Subject: Docket No. 2006-0431  
Investigation of October 15-16 2006 Outage  
Information Request Responses

Hawaiian Electric Company, Inc. ("Hawaiian Electric") respectfully submits nine copies of its responses and objections to the information requests submitted by the Division of Consumer Advocacy on February 1, 2007 in the subject proceeding.<sup>1</sup>

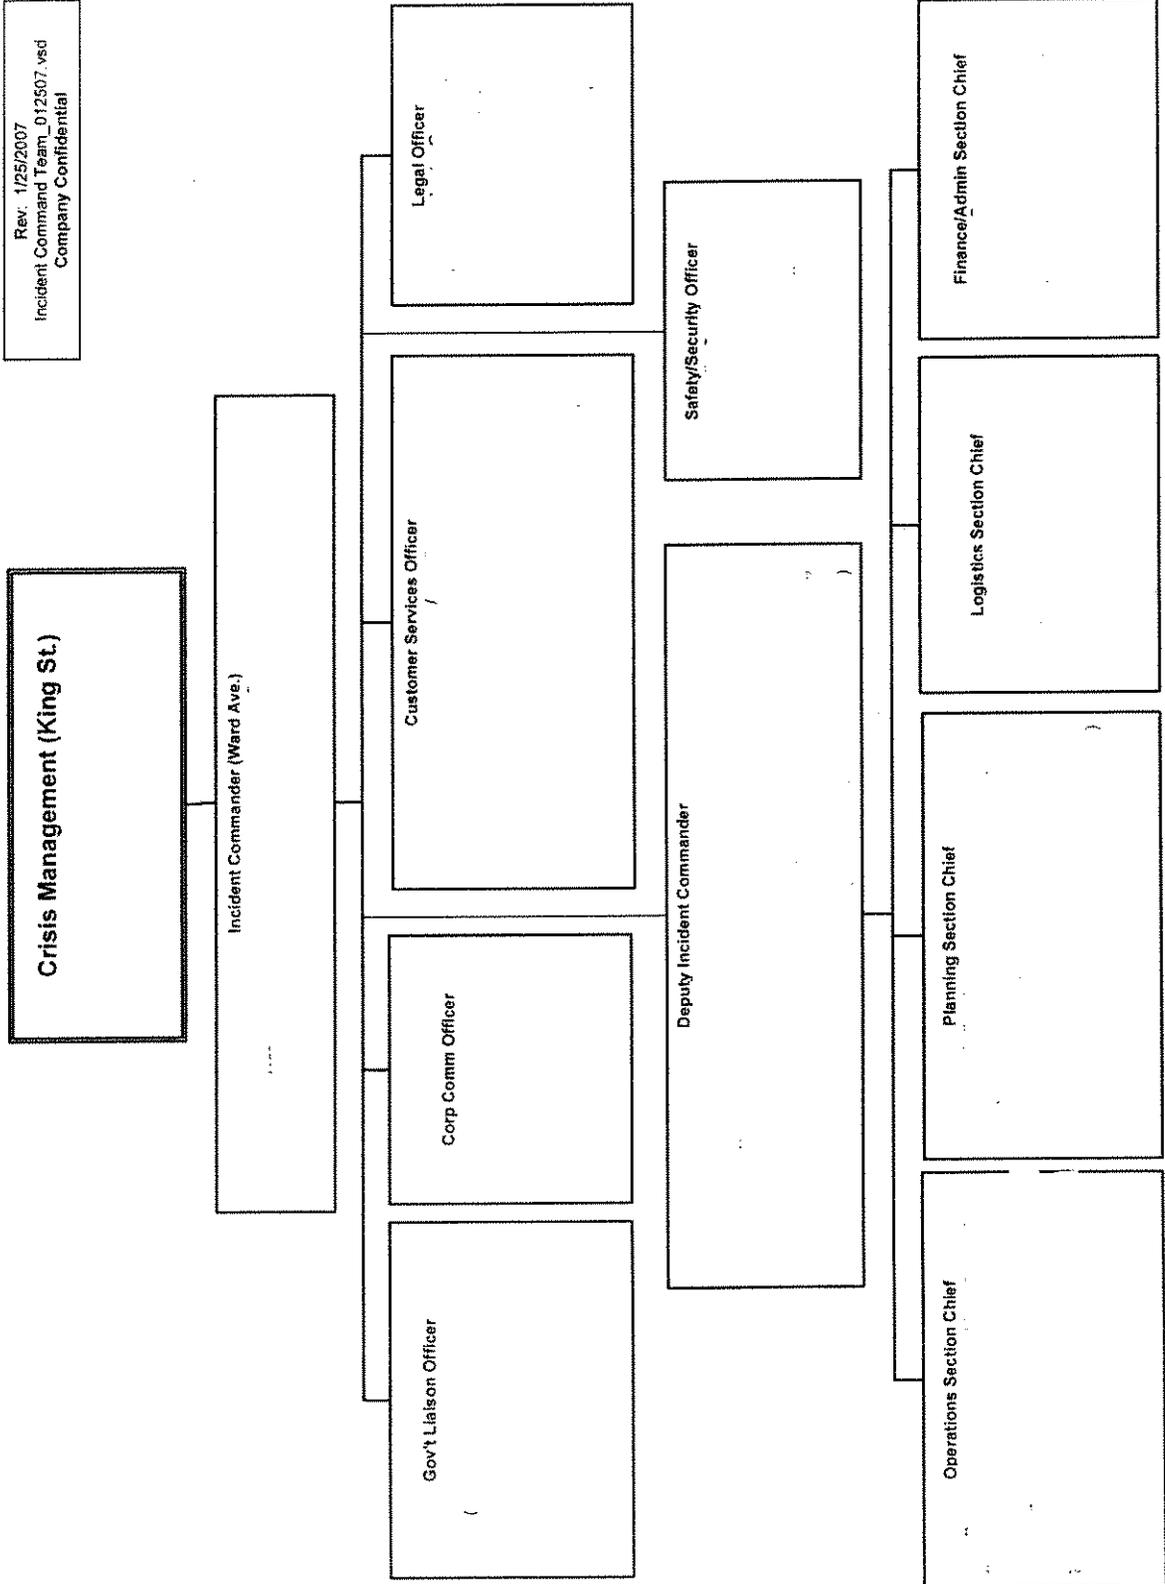
- a. The above document refers to “HECO Incident Command” (here and on page 38). Based on this statement please respond to the following:
  1. Provide staffing of the Incident Command.
  2. When was the Incident Command implemented?
  3. What was the Incident Command’s authority during the events of October 15 and 16, 2006?

- a. The following is provided in response to this request.
  1. Attached page 4 shows HECO’s Incident Command organizations chart. Each position in the IC organization has a primary and backup person to ensure adequate coverage. If both primary and backup personnel are available and respond to an IC call, one will be designated as the primary and the other will either be reassigned or scheduled to support a later shift if the response goes beyond the first operating period. Also the incident command structure is designed with sufficient flexibility to meet the requirements of the

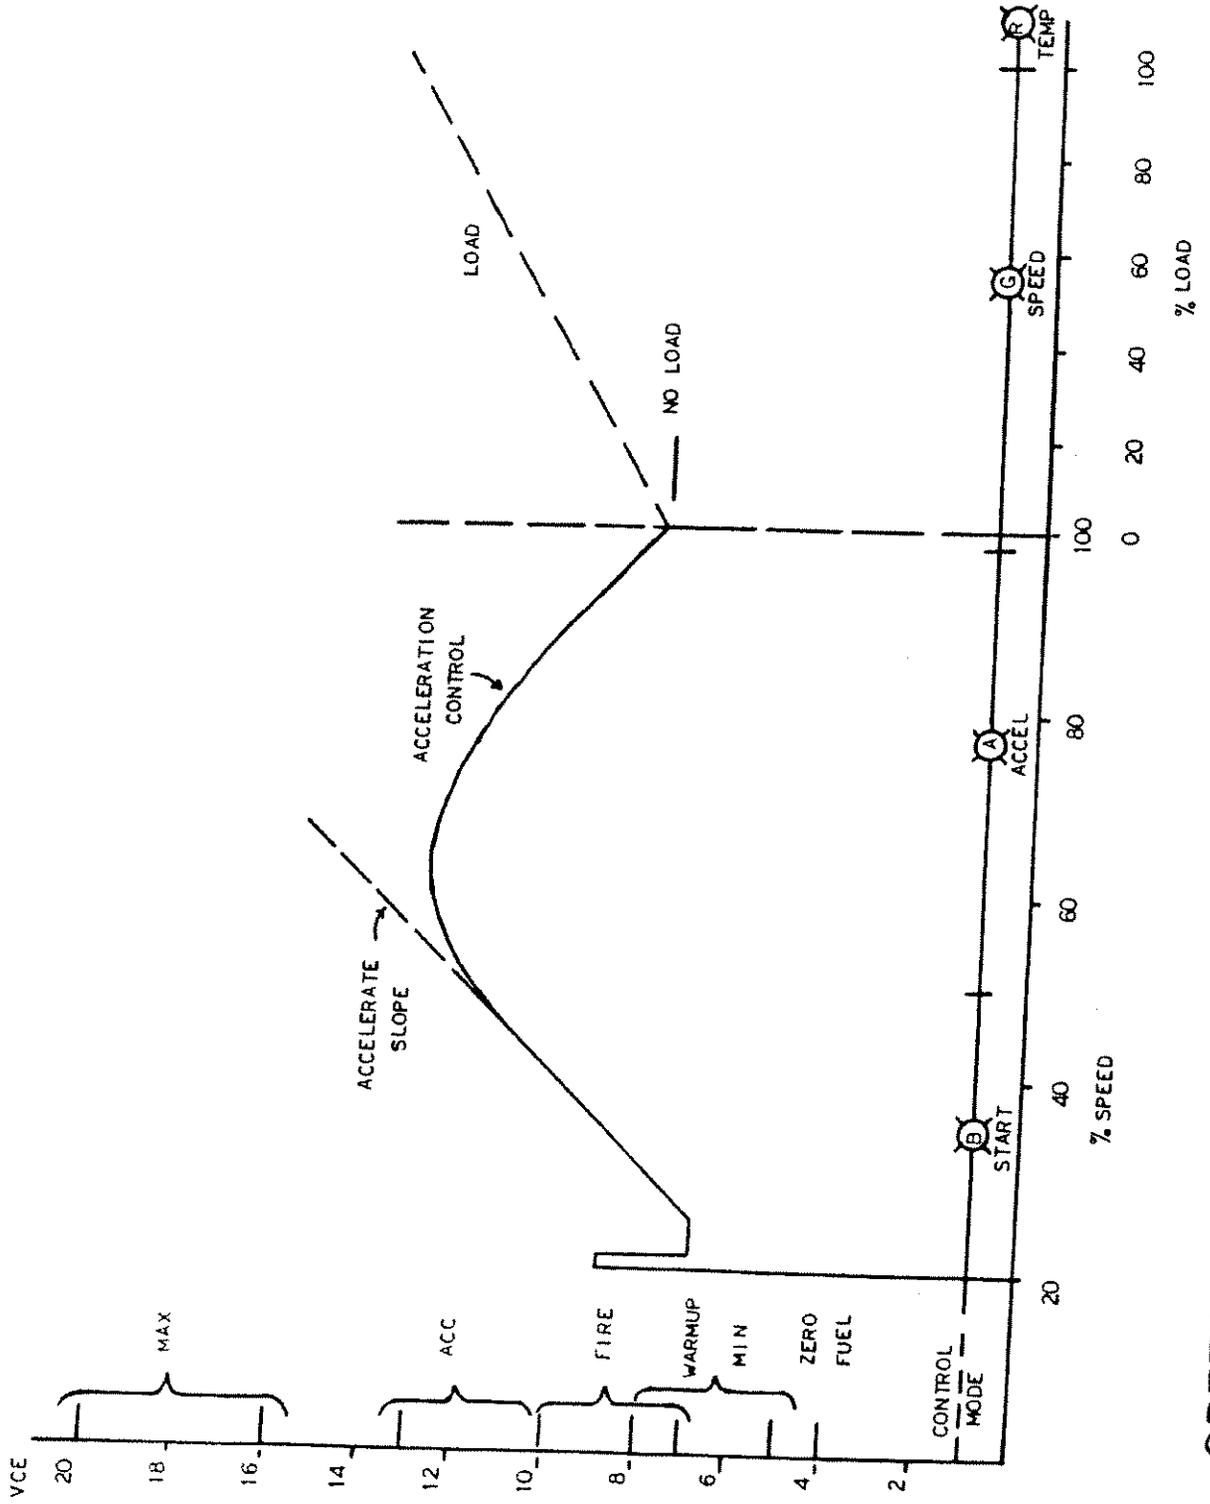
- a. Provide the manufacturer’s starting curve and specific starting sequence and timing.
- b. Describe any emergency start provisions that would result in synchronizing times quicker than 15 minutes.

- a. Please see attached page 3 for a CT fuel supply (VCE) vs. speed/load graph.
- b. On October 15, 2006, when the LD called for the startup of the first CT at 7:09+ the W7 and W8 CO took the initiative to startup up both CTs. By 7:14.30 (approximately 5 minutes after the call for the first CT) the IPP generators had tripped and the system began to collapse. There was insufficient time for either CT to complete its startup process and successfully synchronize to the grid. On page 26 of the POWER Engineers report it states that it takes approximately 15 minutes from initiation of a start to synchronization. The 15 minute time period actually represents the time from initiation of start to the minimum load of 11 MW (previous covered source permit requirement). The initiation of start to synchronization time ranges from approximately 8-10 minutes in both a normal and emergency starts, which is longer than the 5 minutes that the CTs had on October 15th. There are no emergency start provisions which allow an initiation of start to synchronization time faster than the 8-10 minute range.
